Under the **FAST-TRACK APPROVALS ACT 2024**
In the matter of an application for resource consents, concessions, wildlife approvals, an archaeological authority, and approvals relating to complex freshwater fisheries activities in relation to the Southland Wind Farm project
By **CONTACT ENERGY LIMITED**
Applicant

**MEMORANDUM OF COUNSEL FOR CONTACT ENERGY LIMITED
PROVIDING APPLICANT'S REPOSE TO DRAFT CONDITIONS**

23 March 2026

Figure 1 Marginal Strip, track alignment, concession area and stream monitoring logger and gauging locations

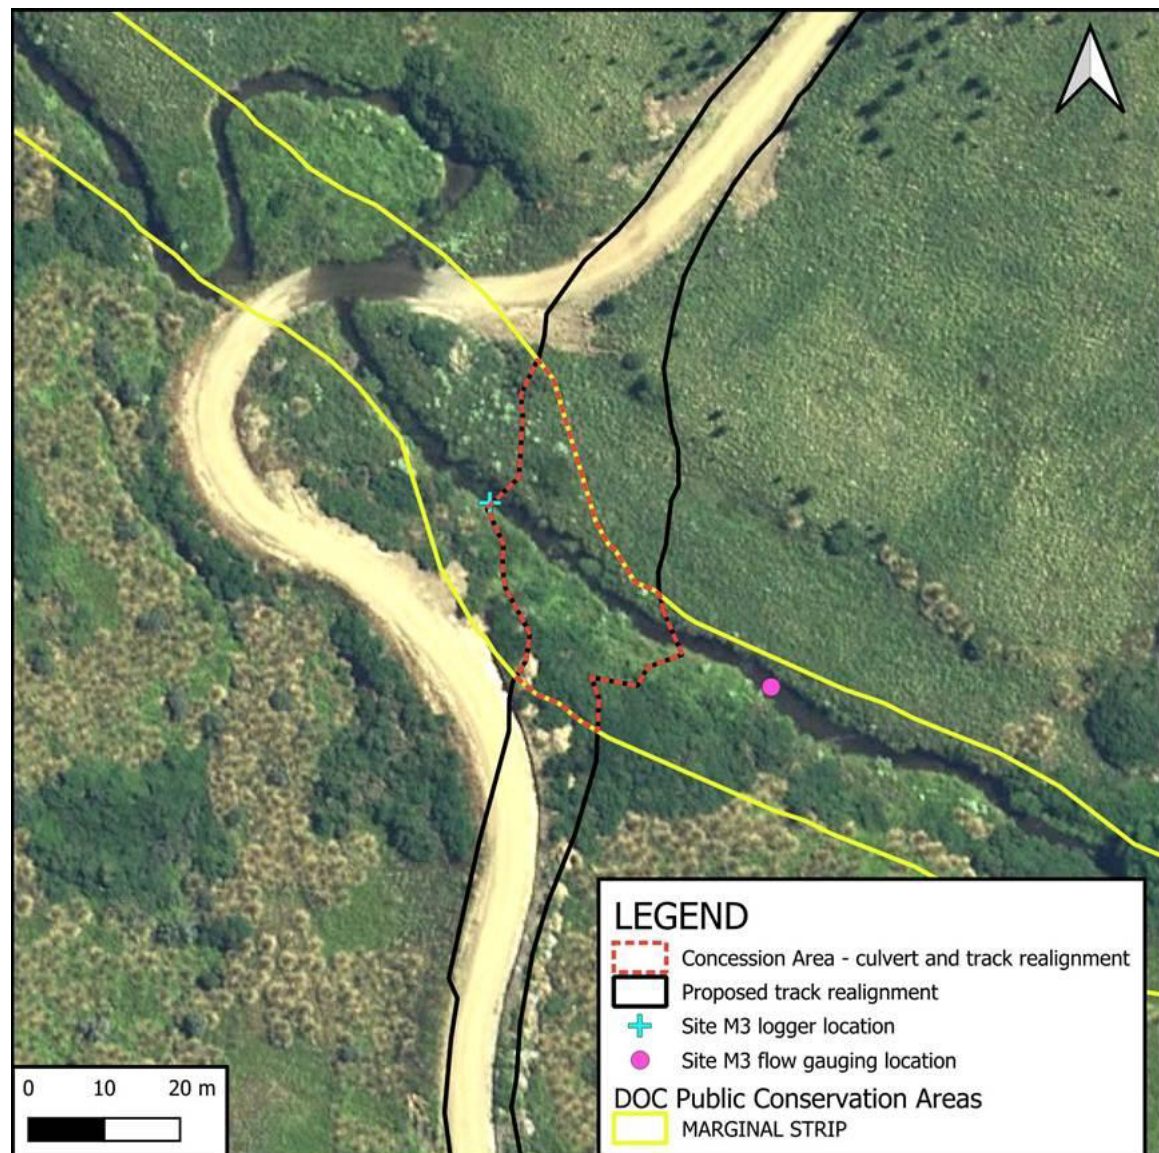
28. Contact appends four figures to this memorandum (**Appendix 1**), as follows:
 - (a) Figure 1 shows the location of the Mimiha Stream North Branch concession land for Culvert NSC1. Figure 1 highlights that the proposed works involve construction of the culvert, and associated works to form a new track to avoid having to drive through the stream via the existing ford (clearly visible in Figure 1).

Figure 4 Concession Airspace Easement Areas

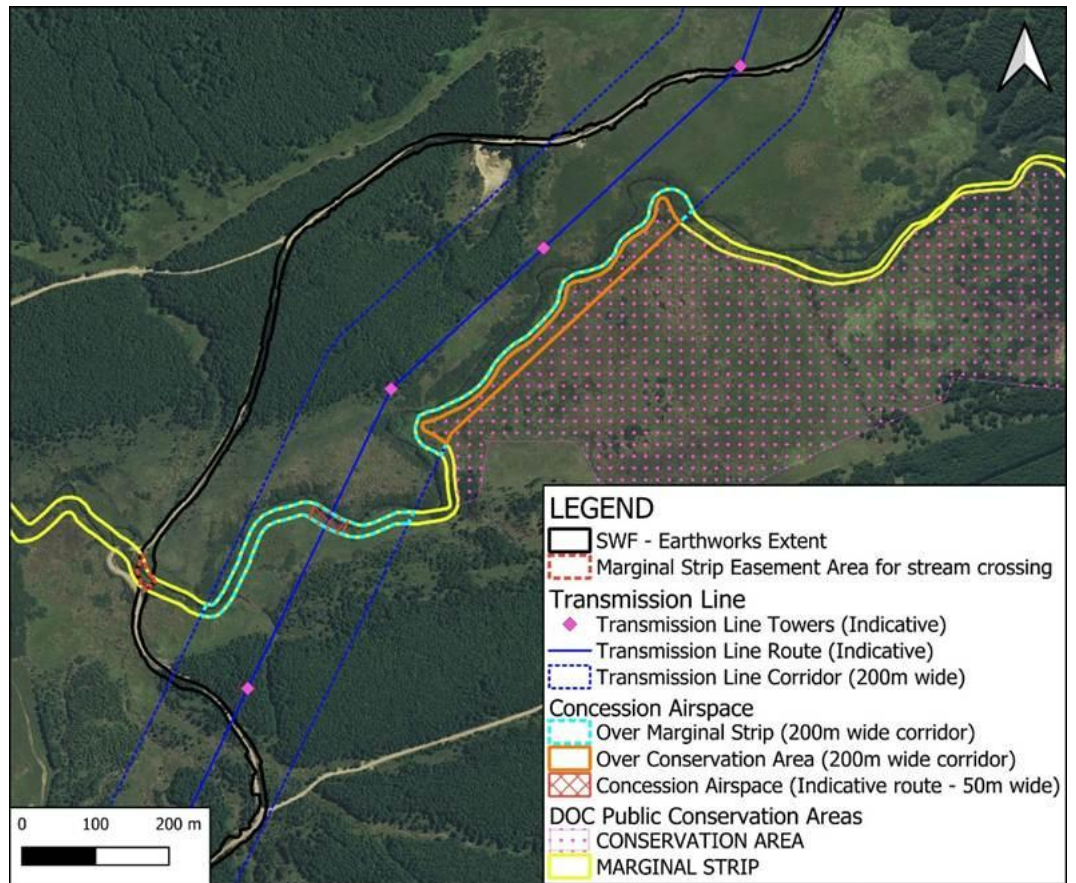
- (b) Figures 2 and 3 are photos of the Mimihau Stream North Branch in the vicinity of the concession area. The vegetation affected by the works has been mapped by Wildlands as being of negligible value, dominated by exotic grasses and gorse.
- (c) Figure 4 shows the location of the concession land for the overhead high voltage transmission line. Of note, there will be no physical ground-level works or interference within the DOC land for the transmission line. Figure 4 also illustrates that much of the marginal strip subject to the concession does not align with the physical stream location.
